ORIGINATION FORM

Proposed Revisions to a Standard Plans Index
(Please provide all information — Incomplete forms will be returned)

Index Number: 715-001
Sheet Number (s): 1
Index Title: Conventional Lighting

CONVENTIONAL LIGHTING

METAL POLE WIRING DETAIL

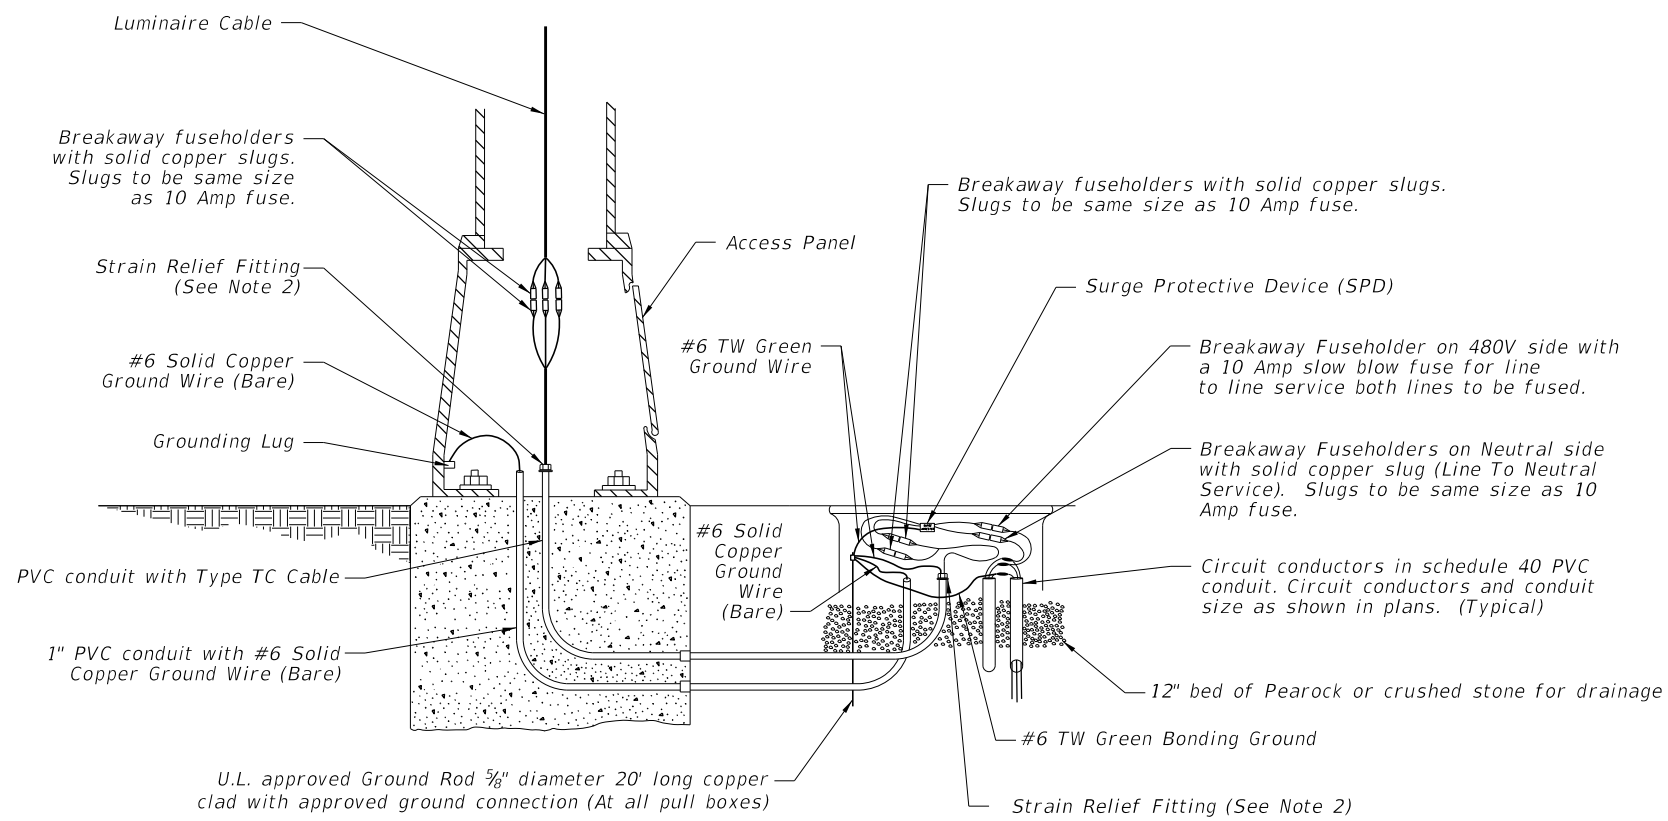
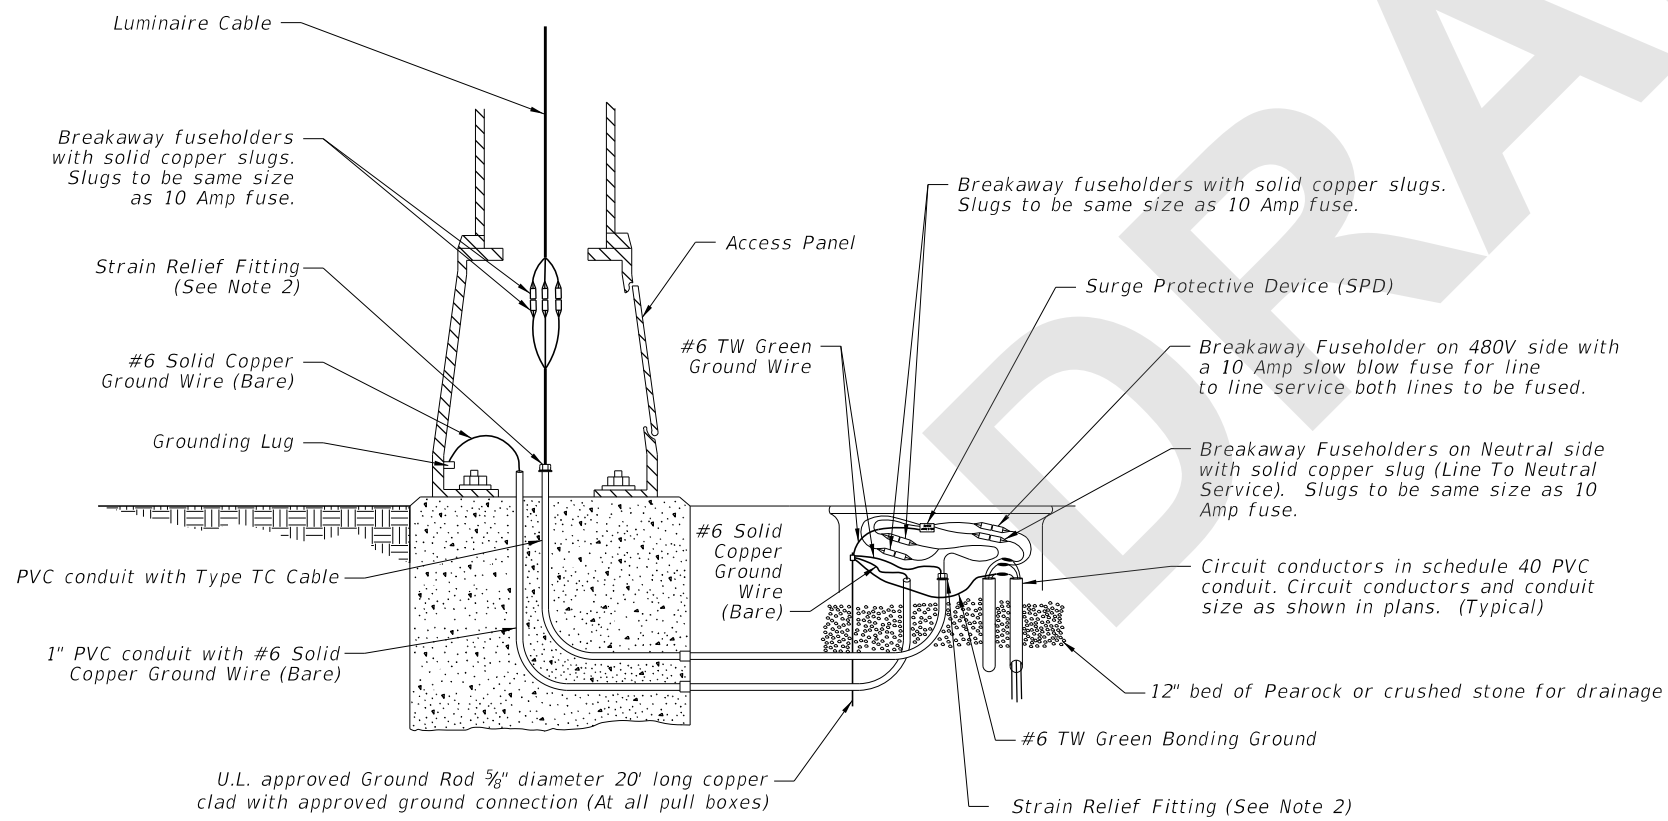
Added additional language to clarify wiring for 715-002 including breakaway fuse holder location

1. Concrete Barrier and Bridge Mounted Poles: Place wiring system following conduit layouts and requirements of Index 715-002. Follow additional requirements of Specification 992. For wiring and devices shown inside of pull boxes on this sheet, place inside of embedded junction boxes instead. Place the vertical breakaway fuseholders inside the pole, at the handhole location.

METAL POLE DETAIL

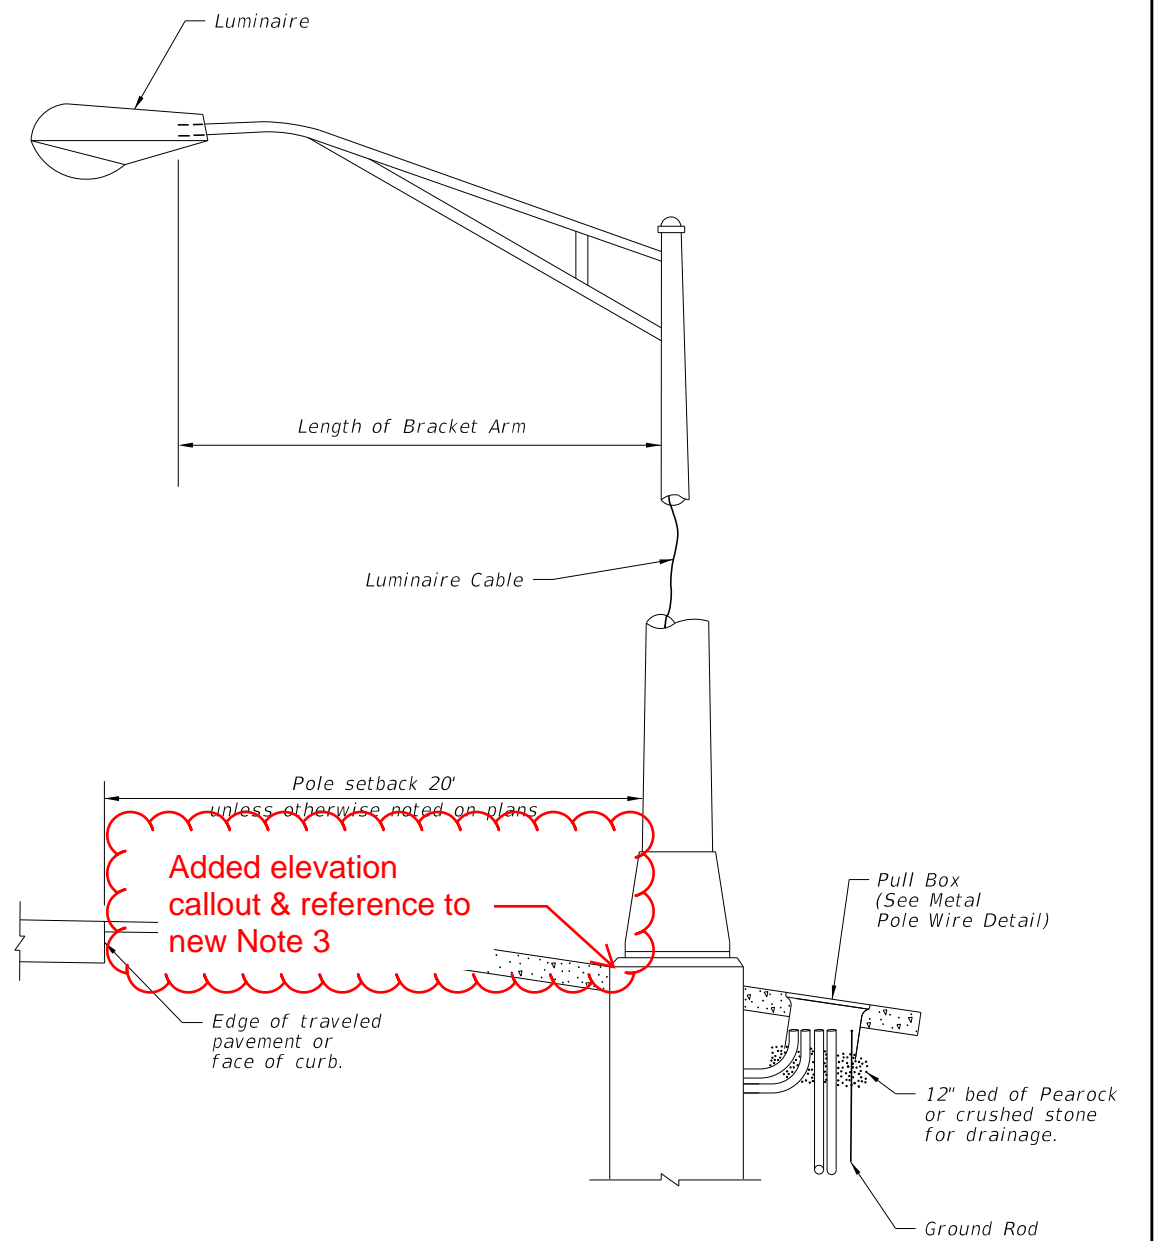
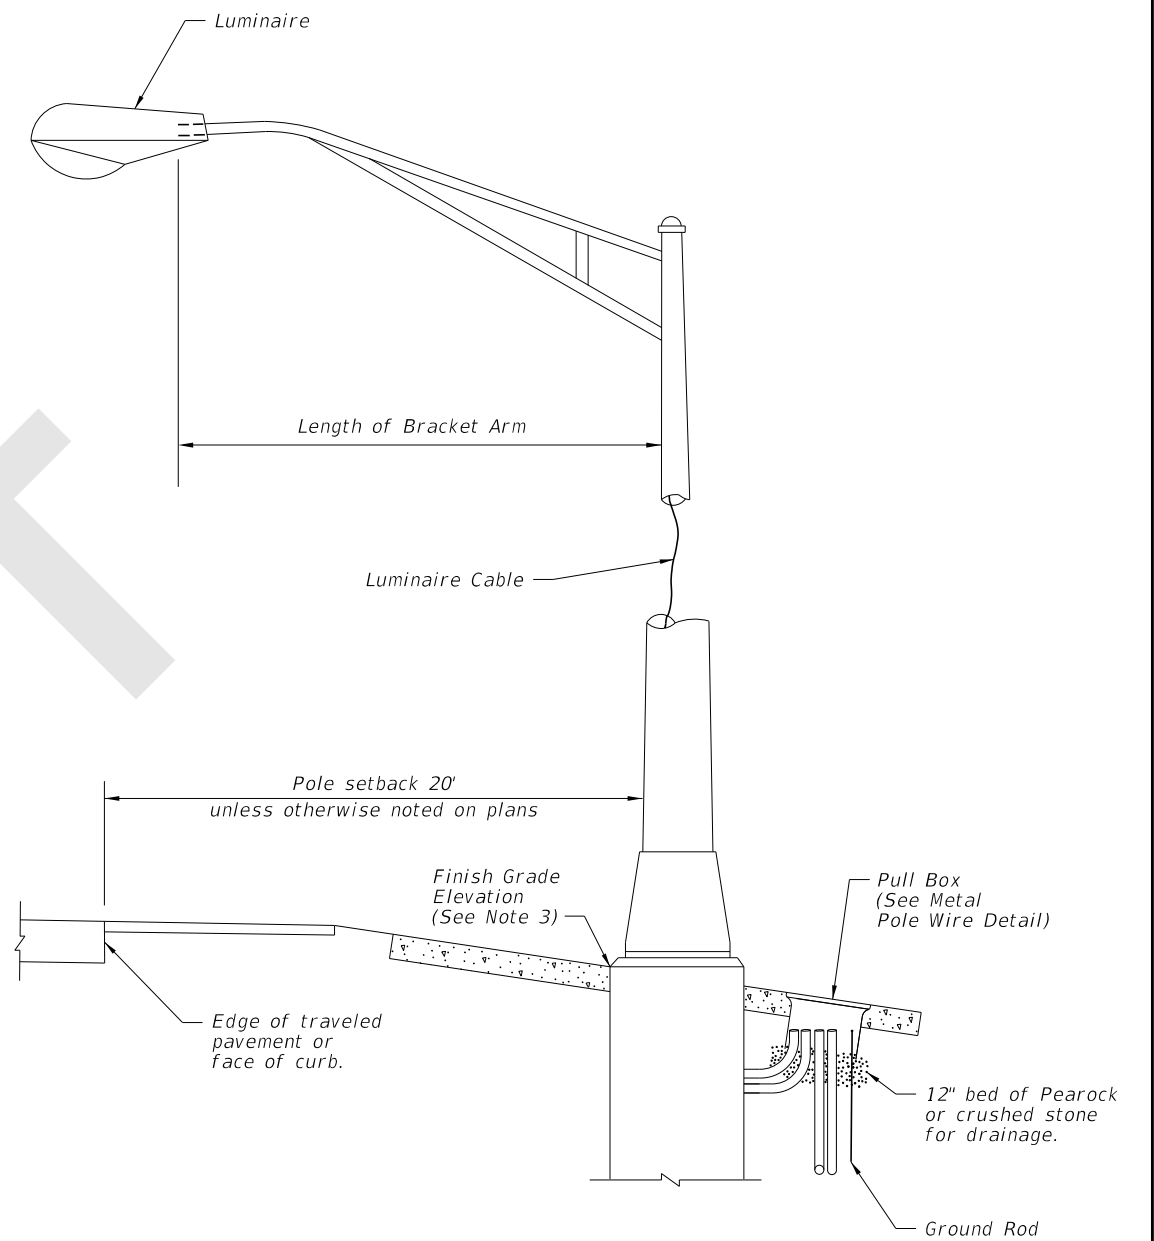
Sheet 1: Updated Note 1 for Concrete Barrier and bridge mount. Provided additional wiring detail, a reference to 715-002, and new information of where breakaway fuse holders fit inside of pole.

Added callout and new Note 3 to explain that the top of the concrete foundation is flush with the finish grade elevation on the side nearest to traffic lane. Added vertical tolerance.

Added new Note 3 for required foundation elevation.

3. Align the top, outside edge of the concrete foundation with the finish grade elevation on the side nearest the traffic lane. Relative to the finish grade elevation, this foundation alignment has a vertical tolerance of plus 2 inches to minus 0 inches.
